From: George Penokie (IBM)

Subject: Comments resolution for SPI-3 Letter Ballot

[All section, table, and figure references in his document refer to revision 10 of SPI-3.](#)

Figure 1 - Example of a differential calibration trace

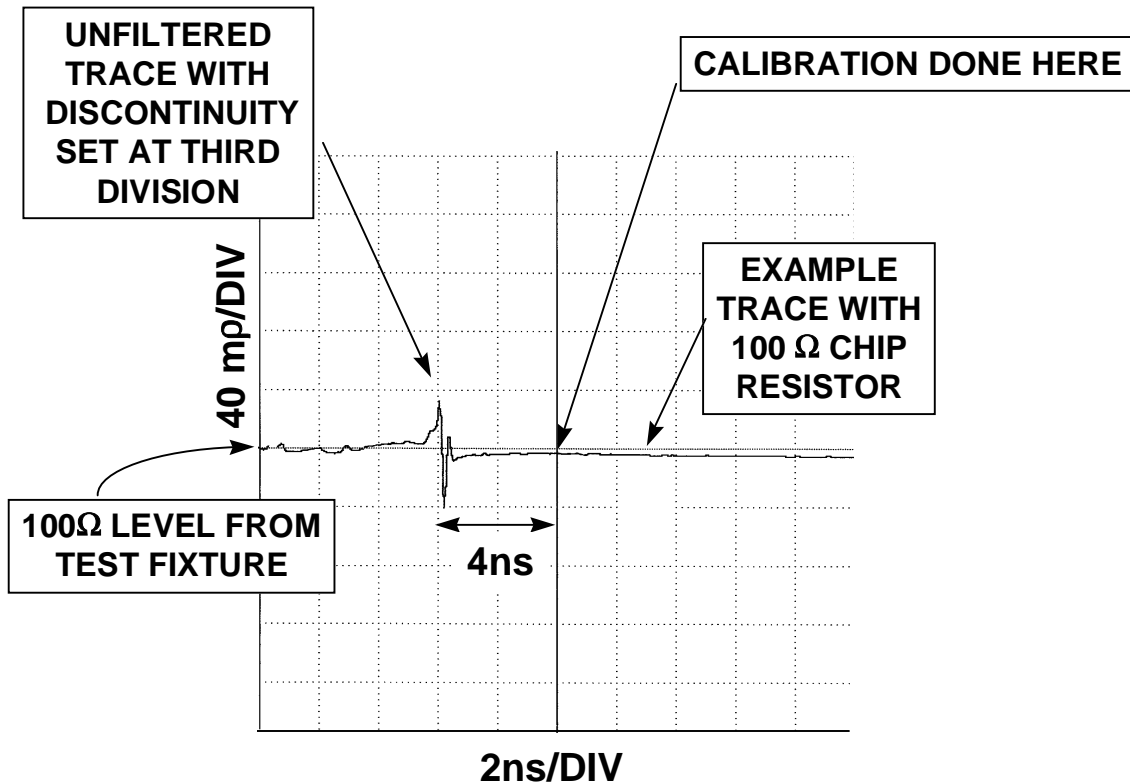
A figure is needed in section E.2.2.2.3 to illustrate the differential measurements.

Add the following words to section E.2.2.2.3 along with the Figure.

Figure x shows an example of a differential calibration trace.

Accept

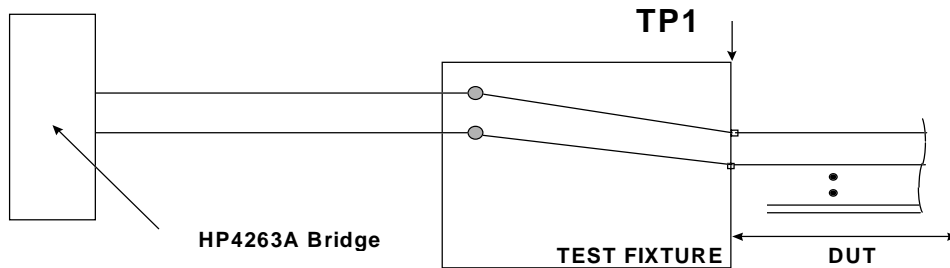
SPI-3: 62.30) technical

In section E.3.1.2

change: See E.2.2.2 for appropriate test fixtures.

To: Figure x shows the configuration to use for this measurement procedure.

Add the following figure x describing the test fixture to section E.3.1.2 with the title "Test fixture for single ended capacitance measurement".

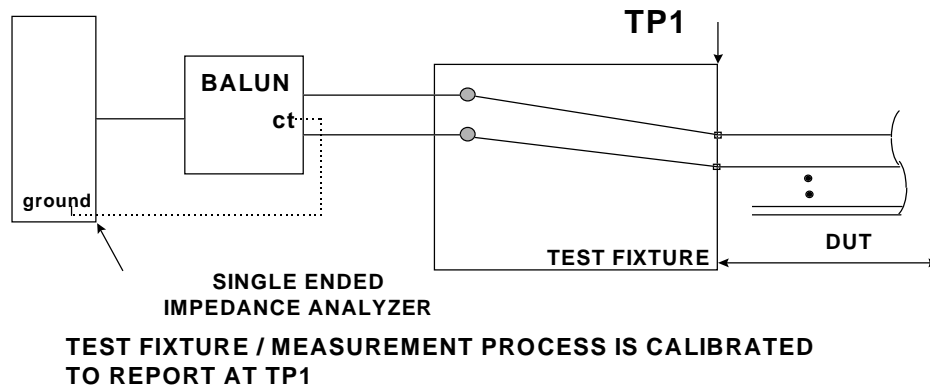
SPI-3: 68.36) technical

In section E.3.2.2

Refer to Figure x for the proper test configuration.

[Add a new Figure x shown below titled "Test fixture for differential capacitance measurements"].

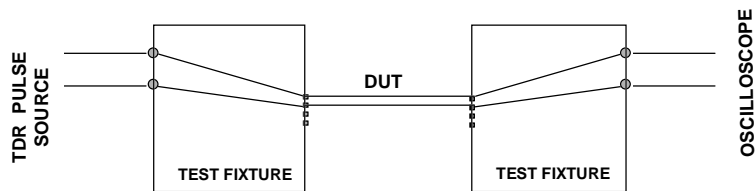
SPI-3: 78.46) technical

In section E.5.2 change:

To: See Figure x for appropriate test fixture.

Add new figure x given below showing the test fixture with the title "Propagation time measurement setup".

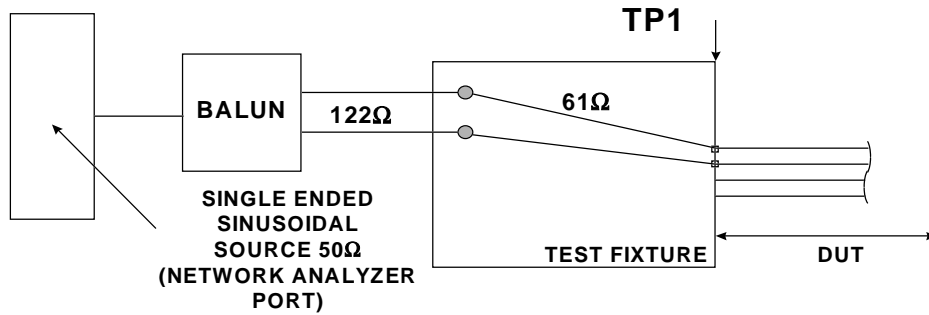
In section E.7.1.1 change

A test fixture having 75 Ω single ended paths for each signal line is used for the measurement as shown in

To:

A test fixture having 61 Ω single ended paths for each signal line is used for the measurement as shown in

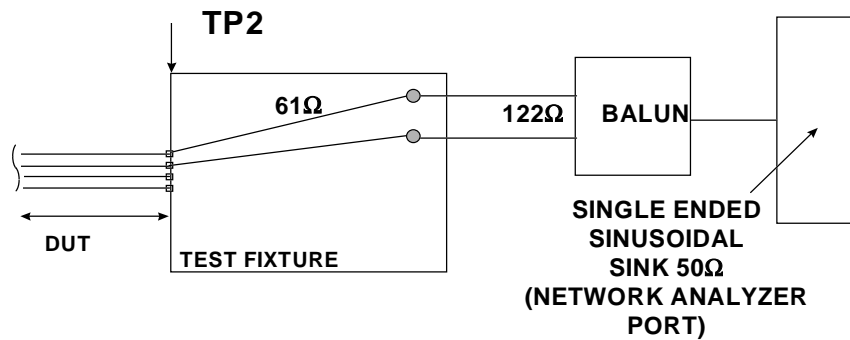
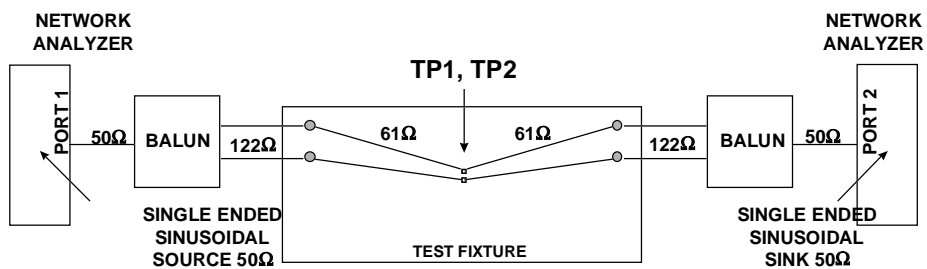
SPI-3: 88.56) technical

In section E.7.1.1 replace Figures E.12, E.13, and E.14 with the following respective figures: (same figure titles)

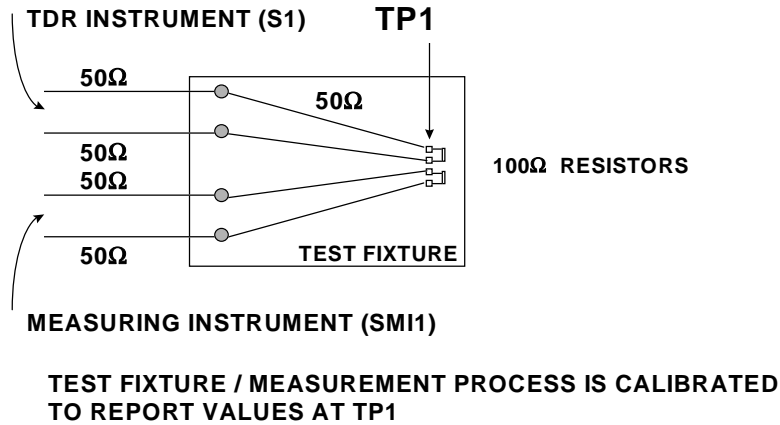
In section E.8.3 change Figure E.17 to:

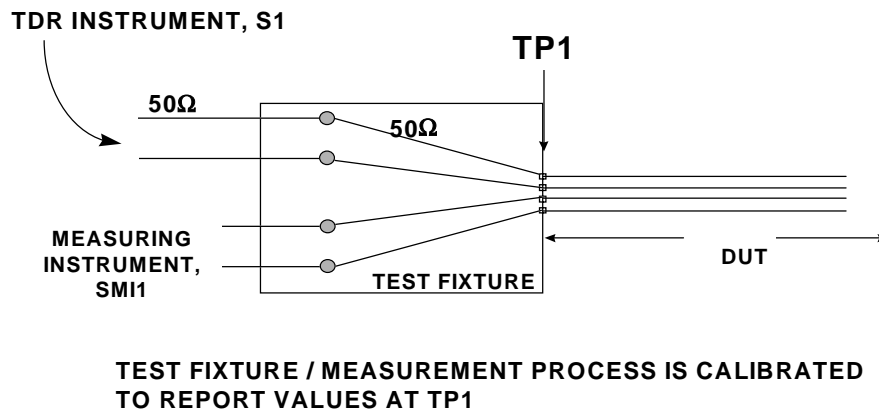
In E.8.4 change: Figure E.18 to:
